Access Compliance Report

Public Rights-of-Way

(Curb Ramps)

Intersection ID: 20081	Main Street: EMERYWOOD_DR	Cross Street: FARMBROOK_DR	Location: E
ADA ID: 4F049392F9FC	Ramp Type: Perp	Initial Pass/Fail: Fail	Overall Compliance: No
		Severity Score: 12.5

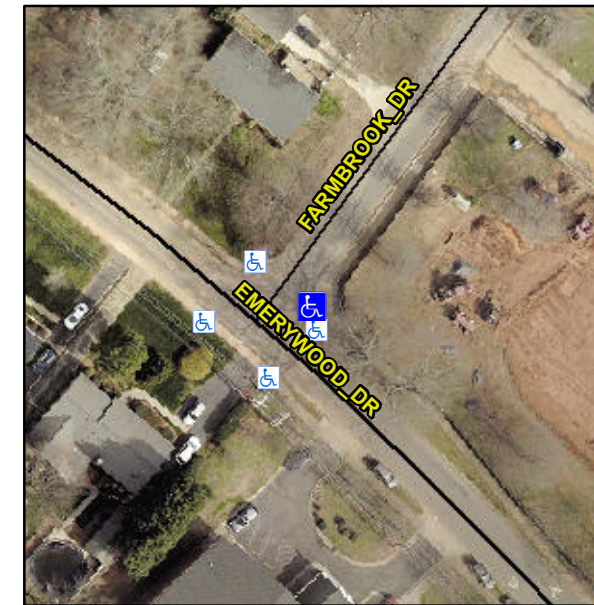
R304.2.2

Compliance	Description	Data	Compliance	Description	Data
N/A	Ramp Length (in)	26.0	No	Ramp Slope (%)	8.5
Yes	Ramp Width (in)	70.0	Yes	Ramp XSlope (%)	1.1
N/A	Flare Type LT	N/A	N/A	Flare Type RT	N/A
N/A	Flare Slope LT (%)	N/A	N/A	Flare Slope RT (%)	N/A
N/A	Flare Traversable LT?	N/A	N/A	Flare Traversable RT?	N/A
N/A	Landing Length (in)	N/A	N/A	DWS Provided?	N/A
N/A	Landing Width (in)	N/A	N/A	DWS Contrast?	N/A
N/A	Landing Slope (%)	N/A	N/A	DWS Length (in)	N/A
N/A	Landing X Slope (%)	N/A	N/A	DWS Full Width?	N/A
N/A	Landing Curb? (Y/N)	N/A	N/A	DWS Offset (in)	N/A
N/A	Shared Landing?	N/A			
N/A	Gutter Ponding?	N/A	N/A	Gutter Slope (%)	N/A
N/A	Gutter Lip Ht (in)	N/A	N/A	Gutter X Slope (%)	N/A
N/A	Painted X Walk1?	No	N/A	Painted X Walk2?	N/A
	X Walk 1 Direction	To NW		X Walk 2 Direction	N/A
N/A	X Walk 1 Width (in)	N/A	N/A	X Walk 2 Width (in)	N/A
	X Walk 1 Slope (%)	0.5		X Walk 2 Slope (%)	N/A
	X Walk 1 X Slope (%)	3.6		X Walk 2 X Slope (%)	N/A

Remove & Replace Entire Ramp.
